I want to oppose SSD-30759158 I haven't made any political donations to report in the last 2 years.

## Appendix U – Wastewater Assessment Report

Minarah College

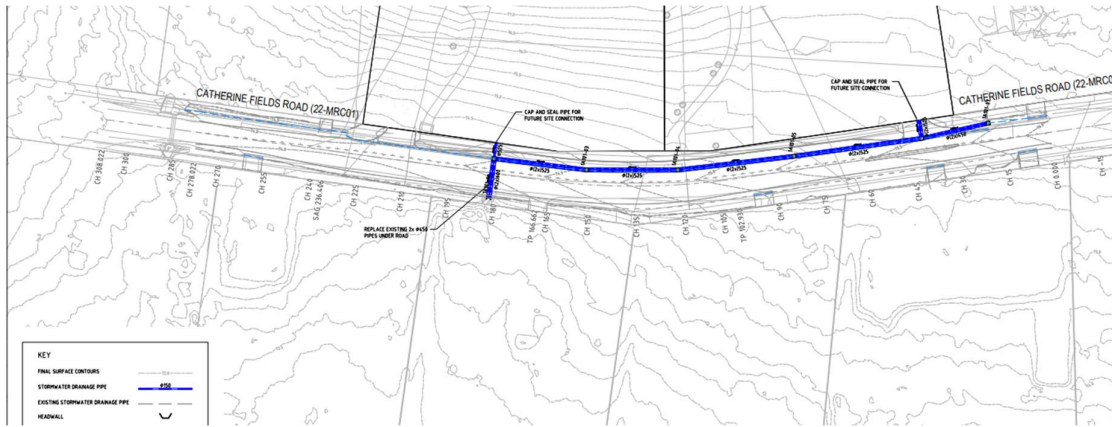
The photo above shows the effect of flooding/ overland flow downstream from the site. The proposed stormwater drainage will not improve this flooding downstream and will effect all downstream neighbours
